ACCESS ASSESSMENT REPORT

5 Skyline Place Frenchs Forest NSW 2086

Project Number: 119909

Revision: 1.1

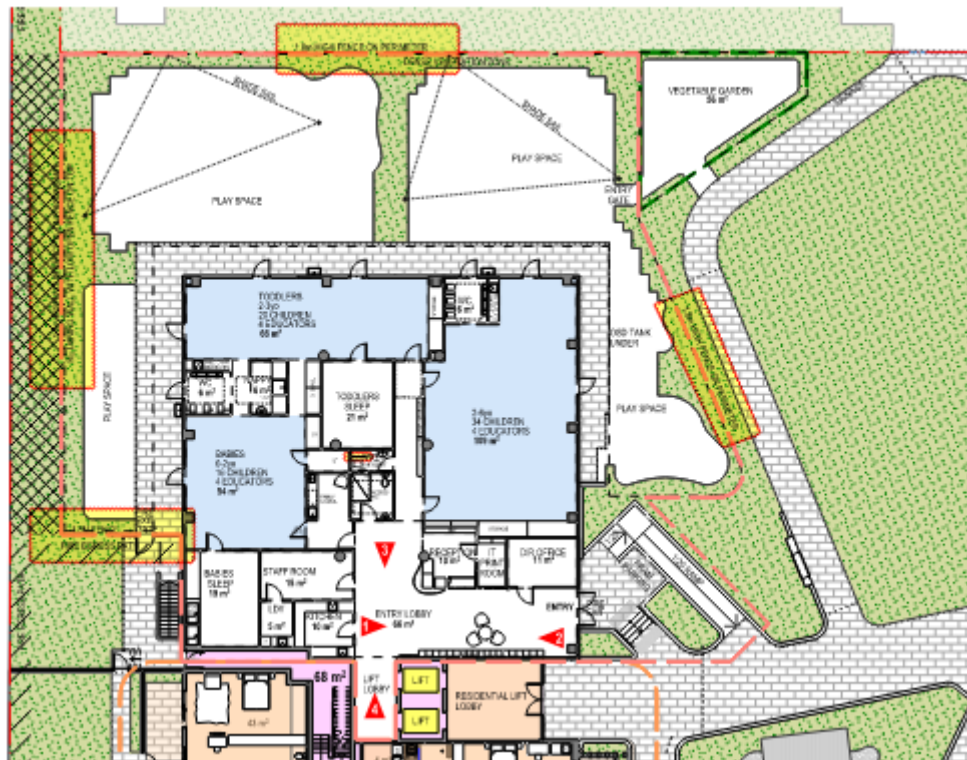
From the Architectural Site plan, it is noted that pedestrian access from the building boundary is provided along Skyline Place where a combination of level and walkway grades of 1:20 are provided onto the entry forecourt at the front of the building entrance. It should be noted that this is a shared accessway for the entire development on this site.

With respect to the Childcare development, which is the subject of this report, the document indicate the provision of 1800mm high perimeter fencing.

A continuous accessible path of travel is located on the southern end via a 1:20 walkway grade to the main entrance. A clear width circa 1500 is provided capable of providing a wheelchair and pram to pass.

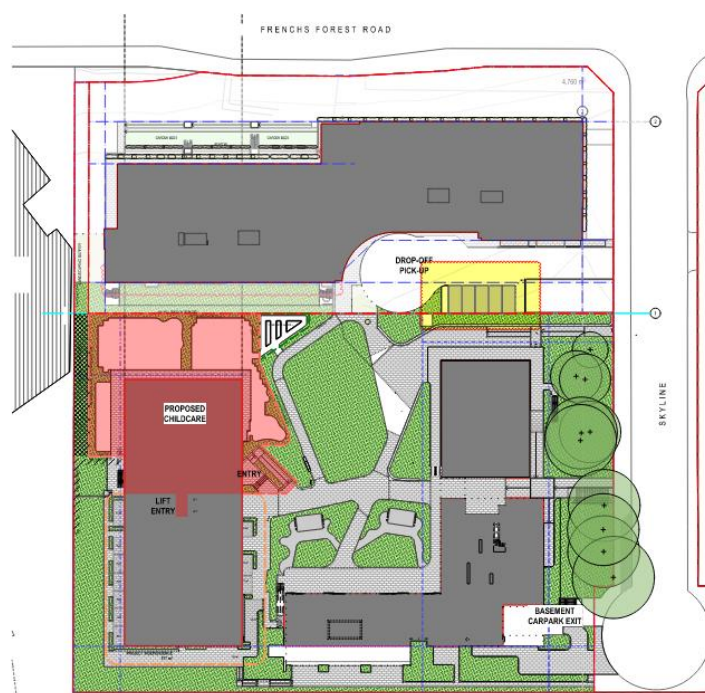
- Landscape documents indicate that walkways to the play areas are at grade with 1:40 cross falls.

Internal corridors where provided is capable of achieving a minimum clear width of 1000mm noted to be located between the Toddlers area and the Babies area.

General circulation space located between Toddlers Sleep and Children Educators, the corridor is capable of achieving a clear width of 1300mm.

Unisex Accessible WC

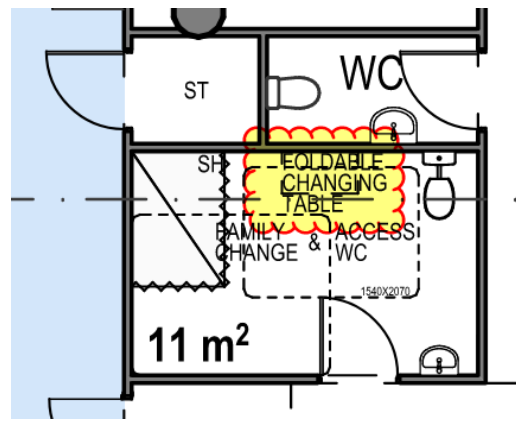
At this stage of the development, one unisex sanitary facility is being provided for staff / visitor use located on the ground Floor. The documents currently indicate that the internal size is capable of meeting the spatial requirements under Clause 15 of AS1428.1-2009.

Please ensure that the foldable change table does not protrude into the pan circulation space when in the up position. This is to be further detailed during post-DA coordination.

Ambulant WC

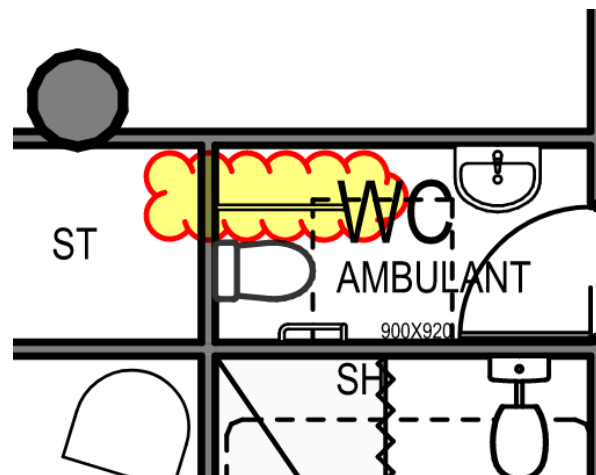
A single unisex ambulant WC facility is provided adjacent to the accessible facilities. It is proposed that a dropdown grabrail be installed in lieu of fixed grabrail in accordance with Clause 16.2 of AS1428.1-2009. This has been identified as a deemed-to-satisfy departure and to be addressed in a separate performance solution at CC subject to PCA concurrence.

Unisex Ambulant facilities – in accordance with Clause F4D4 separate sanitary facilities for males and females must be provided unless the following requirements are met:

- If not more than 10 people are employed
- If the majority of employees are of one gender, not more than 2 employees of the other sex may share toilet facilities if the facilities are separated by means of walls, partition and doors to afford privacy.

This is to be further clarified during post-DA coordination.
